Access Compliance Report Public Rights-of-Way (Pedestrian Signals)

Main Street: **CHAPMAN_AVE** Cross Street: **CANNON_ST** Location: **NW**

ADA ID: **SGRK220103111438** Signal Type: **One Push Button-Non APS** Overall Compliance: **No** Severity Scores: **BTN 1: 35** **BTN 2: N/A** **No BTN: N/A**

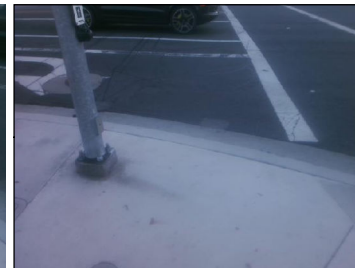
OC Std/PROW: MUTCD 4e.08, R404.2

Possible Solutions: Replace Signal Push Button With APS Button. Remove & Relocate Sign.
